Application for Works Approval

| Works Approval Number | W6685/2022/1 |
| Applicant | Regis Resources Ltd |
| Premises | Duketon Gold Project M38/498 and M38/499 Shire of Laverton As defined by the premises maps attached to the issued works approval |

Figure 7 – Proposed monitoring bores and recommended additional bore (in blue).

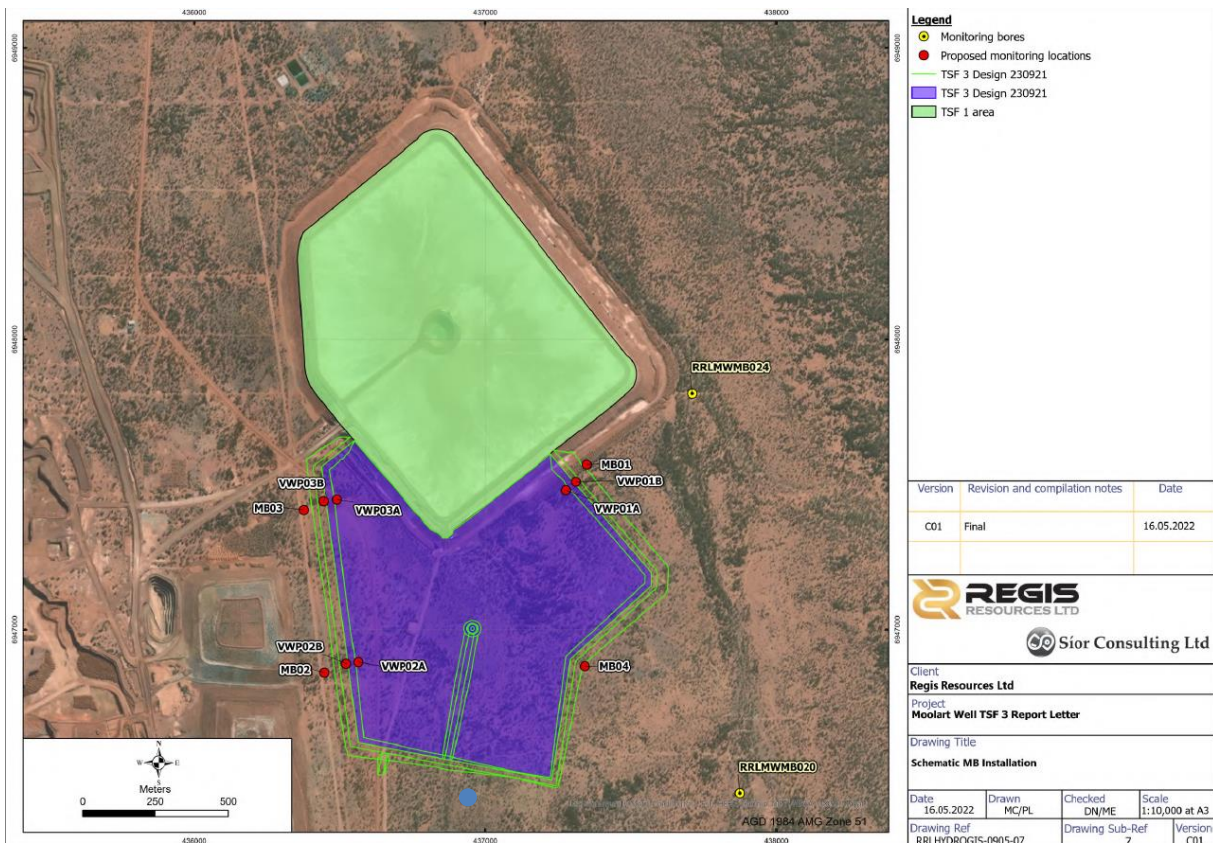
It is recommended that at least one additional groundwater monitoring sites (Figure 7– bore shown in blue) is included in the monitoring network that was proposed in a response to a request for further information. The inclusion of this additional bore sites would enable the radial characteristics of groundwater flow near the TSF to be more accurately determined. Existing groundwater monitoring bores RRLMWMB020 and RRLMWMB024 should also be added to the monitoring program to represent a groundwater regime upstream of TSF3.

The locations of all bore sites in Figure 7 should only be considered to be indicative. It is recommended that the proponent reviews existing geological and geophysical data from the site to ensure that, wherever possible, the monitoring bores are located on suitable structural features that are likely to be significant conduits for groundwater flow.

Design requirements for the construction and installation of the proposed monitoring bores have been imposed to ensure bores are installed correctly and able to detect any contamination.

Figure 8 – Temporary recommended pump locations (in blue).

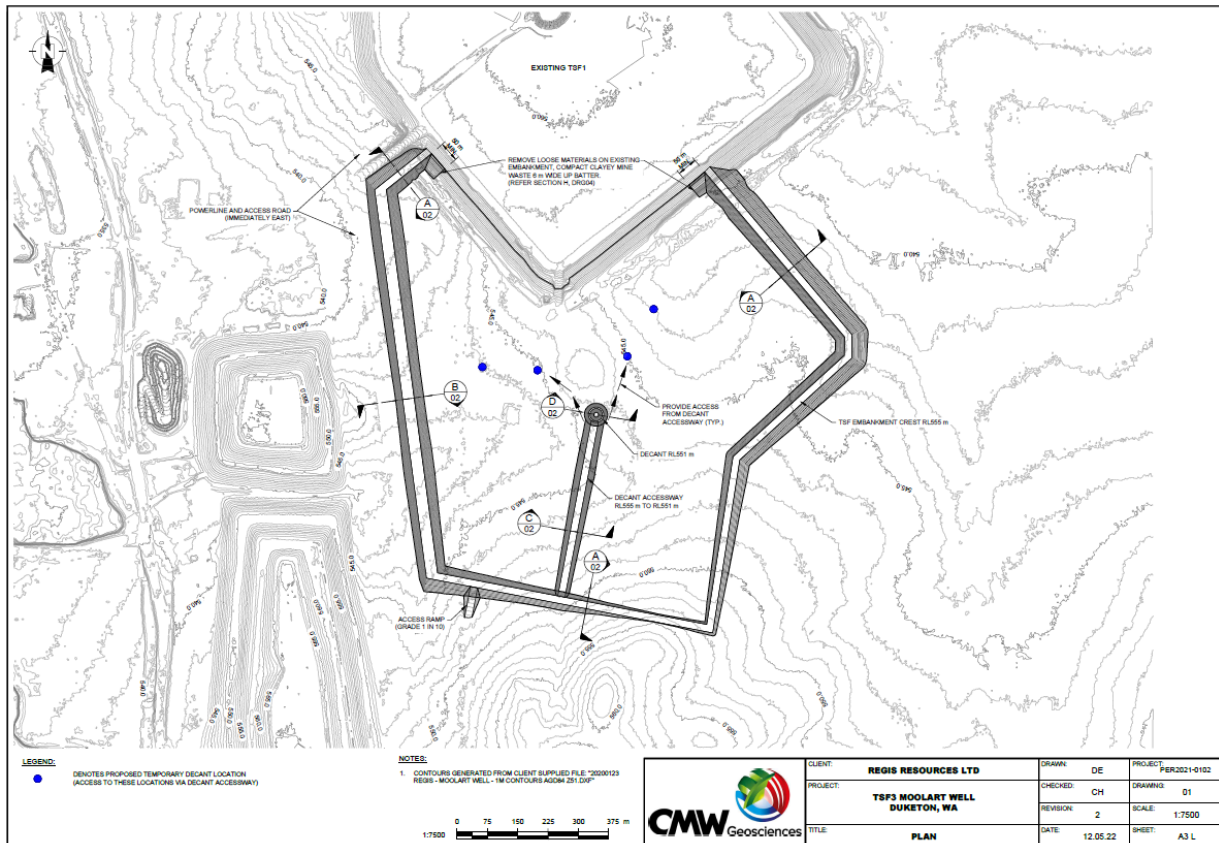
As part of the draft decision documents consultation period, the applicant was requested to revisit proposed design of the toe-drain. Applicant raised a valid point that deepening of the drain would risk damaging the ferricrete layer and increasing its permeability and consequently increasing the risk of perched groundwater flow (interflow) through this unit.

It was also raised by the applicant that the surficial regolith referred to by CSB is a clayey silty and material with a design permeability of $9.7 \times 10^{-7} \text{m/s}$ as indicated from site specific field testing. The excavation and replacement of the surface layer with a compacted “finer textured soil cover” as proposed by CSB would result in a basal liner material of similar permeability to the in-situ materials and therefore not result in a significant reduction of foundation permeability. A supporting memorandum provided by MLW TSF3’s geotechnical engineering consultants was also provided by the applicant. The memorandum indicates that the proposed seepage controls within the proposed TSF design (underdrainage infrastructure), in addition to the proposed strategies to maximise water return to the plant (60% of slurry water inflow), and the minimum capacity requirements for the return water system would minimize seepage surrounding TSF3. The engineering consultants also note that the early water return for the facility is important and water should not be allowed to accumulate on the facility at start-up (i.e. over several months). Several temporary pump locations should be located within the TSF3 basin to ensure early water return. These locations should comprise a temporary pump within a small rock ring or sump. Suggested locations are shown in drawings below in blue (Figure 8).

Following a review of applicant’s response and further consultation with CSB hydrogeologist, the Delegated Officer considers that there is still a risk that perched flow could occur within the ferricrete unit. This is because although the matrix of this unit may have a generally low permeability, experience from similar materials elsewhere in the region has indicated that ferricretes can often contain highly permeable zones where there are interconnected macropores which may not be detected in pit-scale permeability testing. Additionally, as perched aquifers in ferricretes may not necessarily be in direct hydraulic connection with deeper aquifers, the shallow remaining seepage might not be captured by the dewatering cone of depression. Consequently, there is still a risk that shallow seepage would be a pathway for transport of contaminants from the TSF which would require monitoring and adequate control. A condition has therefore been imposed to ensure water is not allowed to accumulate on the facility at start up (considered as commissioning and time limited operations phases in the works approval context) as recommended by MLW TSF3 consultant engineers. Also, condition 4 requires applicant to review and install seepage recovery infrastructure in addition to the TSF3 underdrainage seepage recovery system (cut off trenches and sumps included in the TSF3 design report). At minimum RRLMWPB013, needs to be reinstated and/or available for seepage recovery (however its location and targeted aquifer need to be verified to confirm its suitability as an effective recovery bore for TSF3).
